PL202500152
PL2025-152

541 West 90th Bloomington
2025 Floor Plans

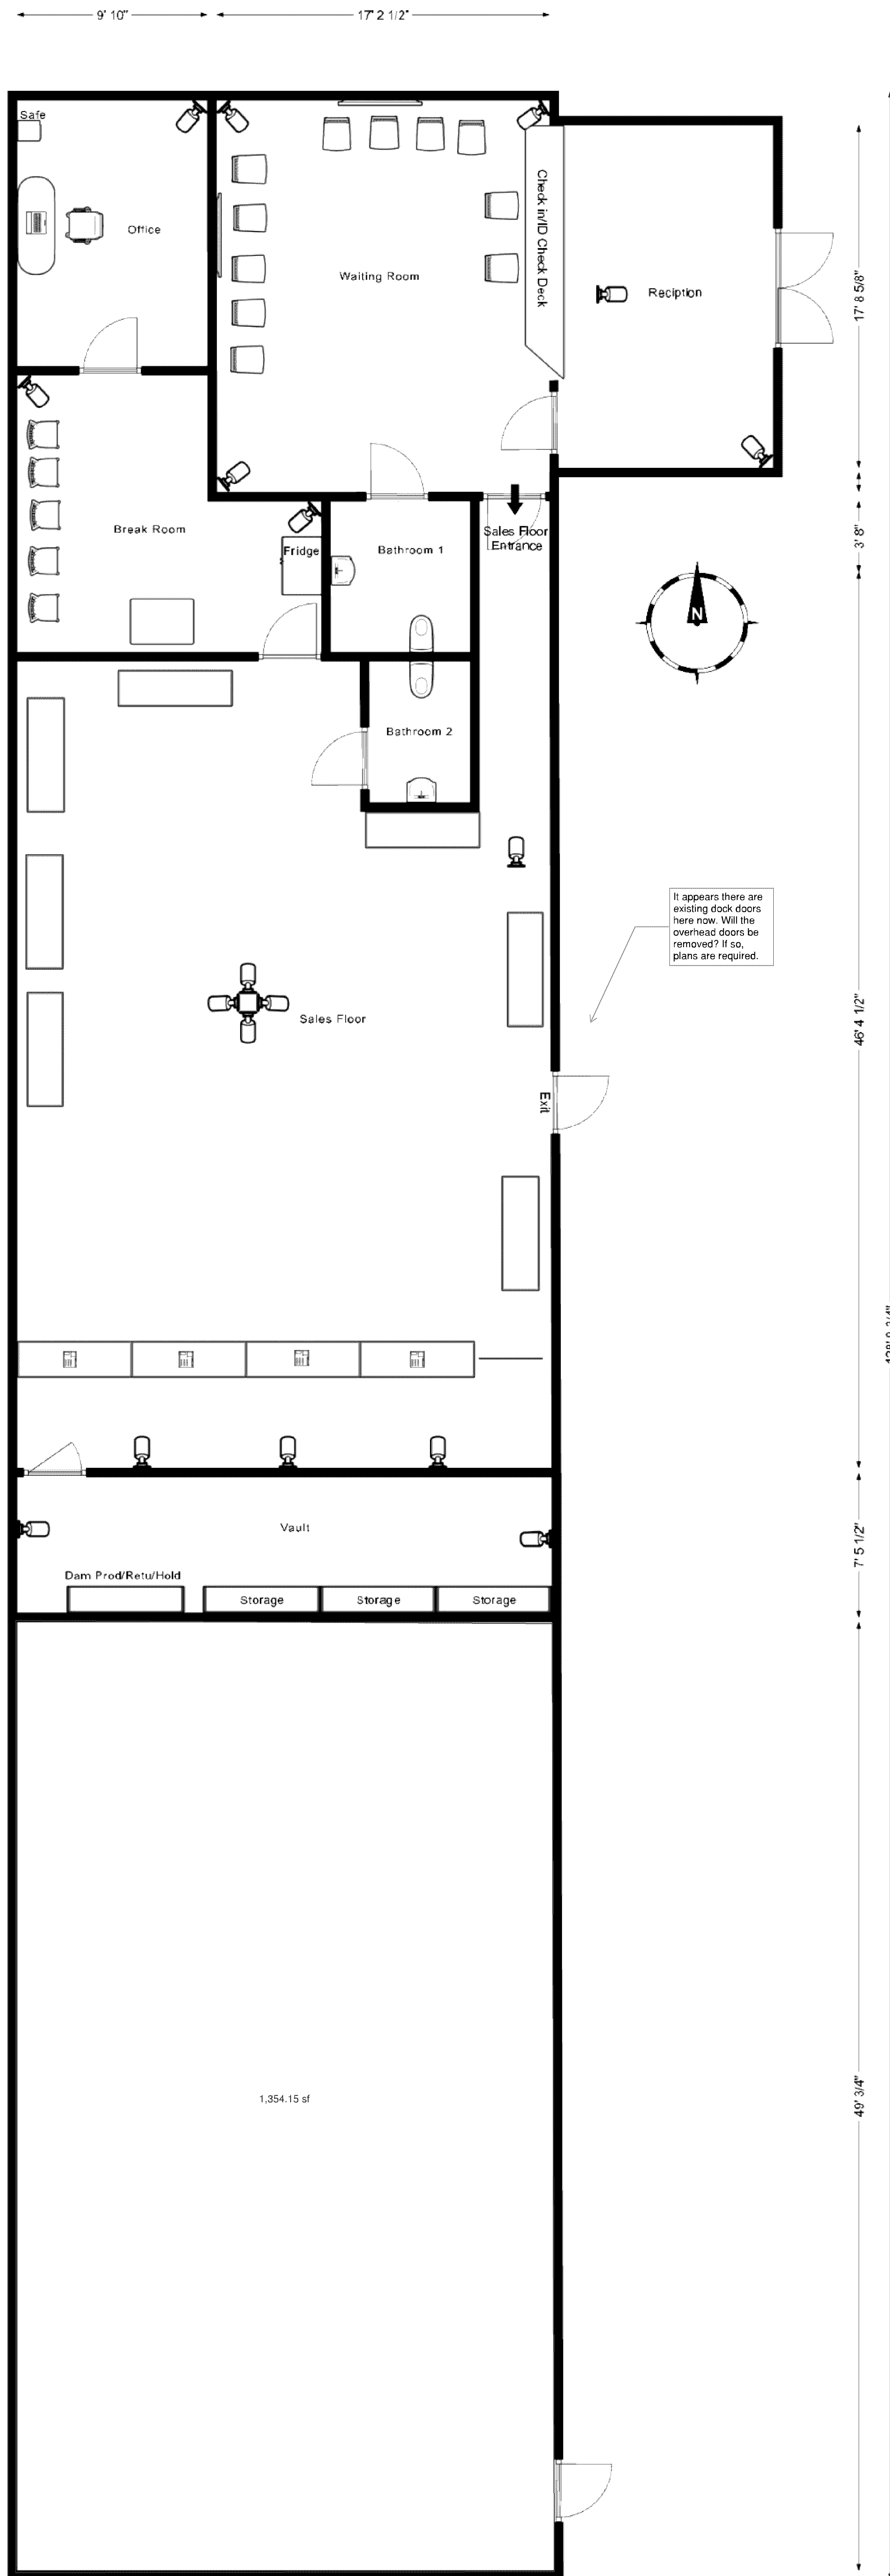
Building/property shall be adequately signed for emergency response.

Entire occupant shall have fully complying sprinkler protection.

A looped water supply feeding a single, combined water service is required for the domestic and sprinkler system water demand.

Maintain emergency vehicle access and circulation throughout the property.

Additional requirements apply to manufacturing and/or grow operations.

Hydrant coverage shall be provided within 50' of the FDC and within 150' of all portions of the structure.

It appears there are existing dock doors here now. Will the overhead doors be removed? If so, plans are required.
